RENESAS TECHNICAL UPDATE

Product Category	MPU&MCU		Document No.	TN-SH7-A568A/E	Rev.	1.00
Title	Notice for DREQ sampling in case of the split of DACK for external access		Information Category	Technical Notification		
Applicable Product	R4S76190***** HD6417641BP100 HD6417710 HD6417712 R4J7710ABG	Lot No.	Reference Document	SH7619 Group Hardware Manual (REJ09B0237-0100 Rev.1.00) SH7641 Hardware Manual (REJ09B0023-0300 Rev.3.00) SH7710 Group Hardware Manual (REJ09B0079-0200 Rev.2.00)		
		ALL

Fig1.Example ofDREQ Input Detection in Cycle Steal Mode Edge Detection
When DACK is split to 4 due to 16 Cycles.

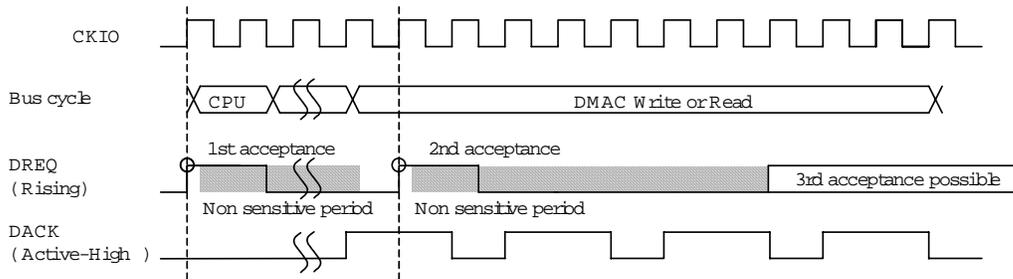
There are cases that when DACK is split for an external access, DREQ can be sampled twice in that access.

- 1) For DREQ edge detection: please input one DREQ edge at maximum in that external access.
- 2) For DREQ level detection in overrun 0: please negate DREQ after the detection of the first DACK negation and before the second DACK negation.
- 3) For DREQ level detection in overrun 1: please negate DREQ after the detection of the first DACK assertion and before the second DACK assertion.
